DESIGN REVIEW BOARD RECOMMENDATION MEETING

JANUARY 26, 2016

4730 32ND AVENUE SOUTH

DPD #3019613

DEPARTURE: REAR YARD SETBACK  
23.45.518.A: SETBACKS FOR LR ZONES

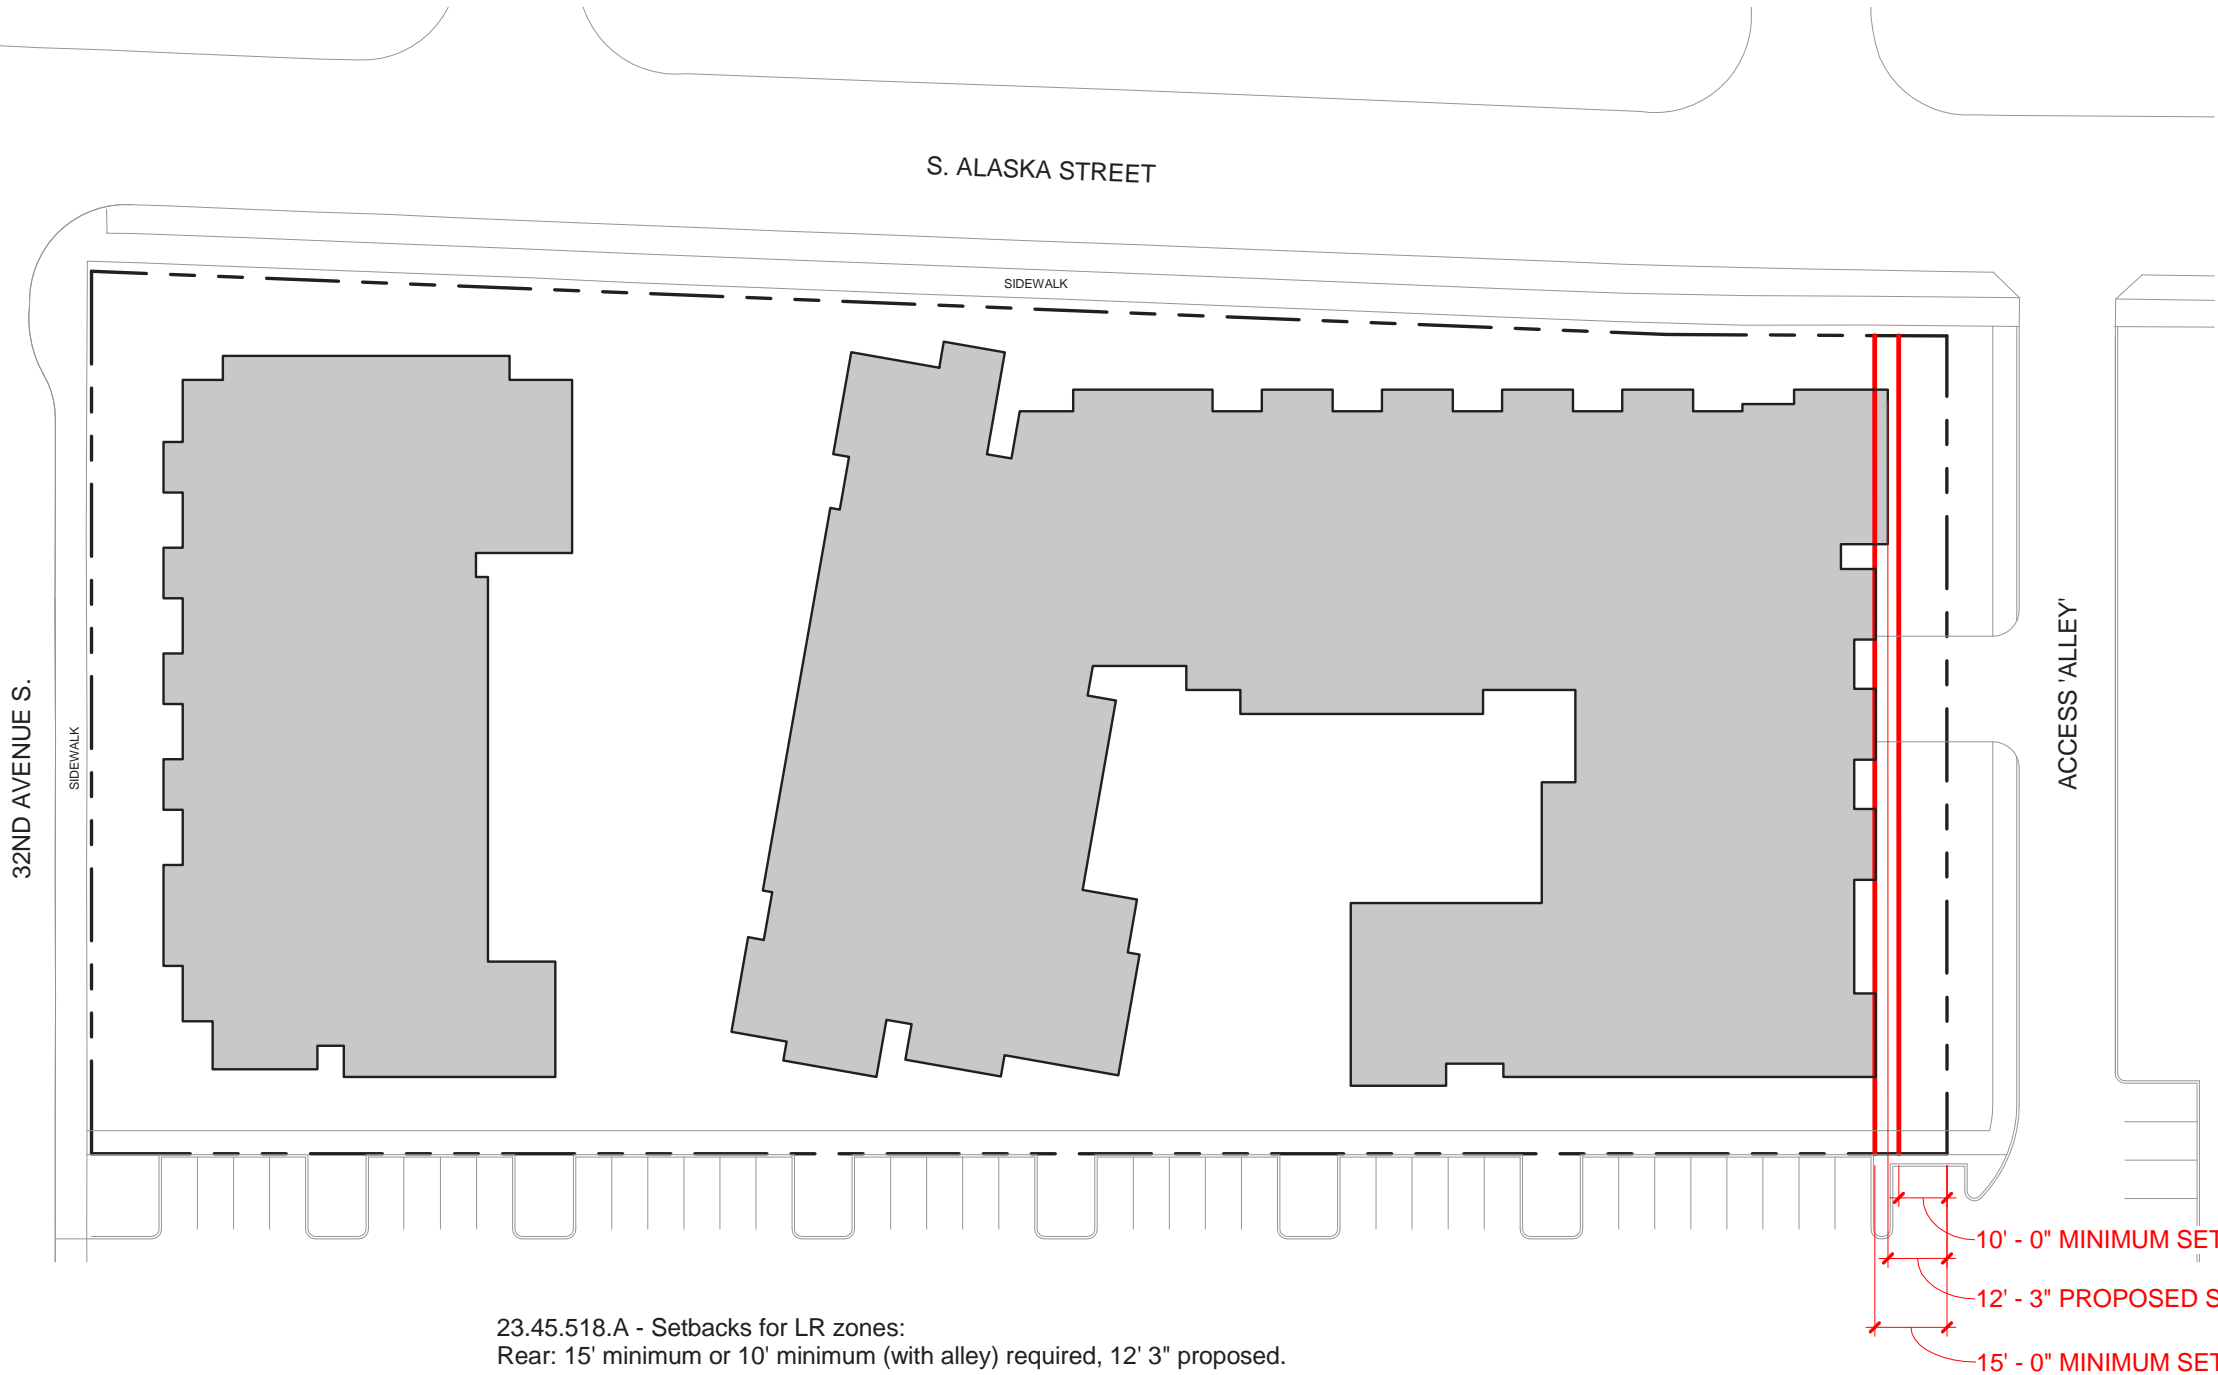
The design team is seeking a departure to allow for the portion of the adjacent site, used as vehicular access to both sites, to serve as an ‘alley way’ in terms of setback requirements. Since there is an easement planned with the adjacent property (under same ownership), the function is identical to a public alleyway for accessing the property. Therefore we seek a departure to treat it as such, and propose a rear yard setback of 12’ 3”, which is in excess of the 10’ required under the alley-way rear yard setback provision.

REQUIRED: 15’ - 0” minimum setback, reduced to 10’ - 0” if rear yard faces an alley.

PROPOSED: 12’ - 3” setback.

S ALASKA ST, OPTION A (PREFERRED)

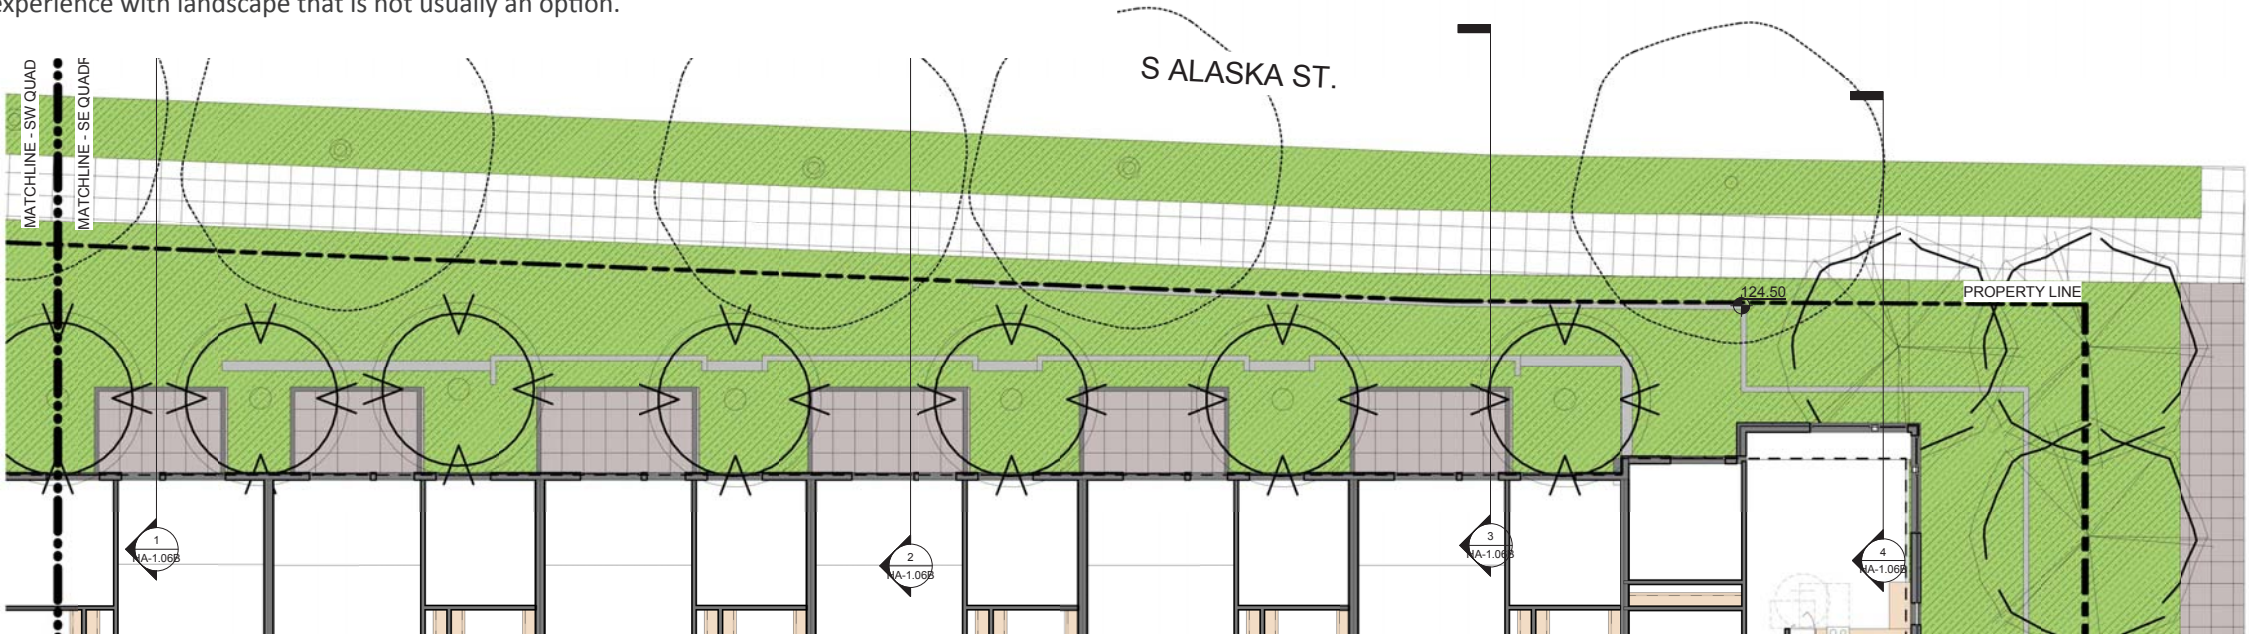
“The Board acknowledged that S Alaska St is in many ways the front door to both phases of the development. The massing and ground level treatment along 32nd Ave S seems successful in creating a pedestrian oriented street edge. The Board would like to see the S Alaska St frontage developed as well to respond to the streetscape. (Guidelines CS2-B-2, DC2-A-1)”

“The Board was also concerned with the character of the elevated terraces facing Alaska and urged the applicant to develop the scale and transition of these private spaces well. Consider repeating the townhouse vernacular along S Alaska St (Guidelines CS2-B-2, PL2-B-1, PL3-B-1, PL3-B-4)”

In developing the project further to react appropriately to the public realm, the design team took into careful consideration two key realities.

- 1. The quality and character of the S Alaska St streetscape is that of a busy arterial flanked by well used sidewalks. (CS2-B-2)
- 2. The varied topography of the site requires special consideration with respect to orienting pedestrian and vehicular access to the project. (DC2-A-1)

Taken together, these inform the design in the following manner: Since S Alaska St is a busy arterial with no on-street parking, greater noise and traffic speed, a townhouse typology is not appropriate at this location. While the design team did explore the possibility of creating direct pedestrian connections from the sidewalk to the Level 1 units, the topography of the site limits these to just three units before the landscape becomes too steep to create a meaningful connection (see section drawings, opposite page). We chose instead to create a much more pedestrian friendly terraced landscape that serves as a buffer between the street and the private decks at the Level 1 units. We feel that this approach responds much better to the site characteristics, and strengthens the pedestrian entry to the entire project. This also allows us to take direct advantage of the otherwise challenging topography of the site to orient vehicle and pedestrian entries at their most appropriate and readable locations, and allow a unique opportunity to create a great pedestrian experience with landscape that is not usually an option.
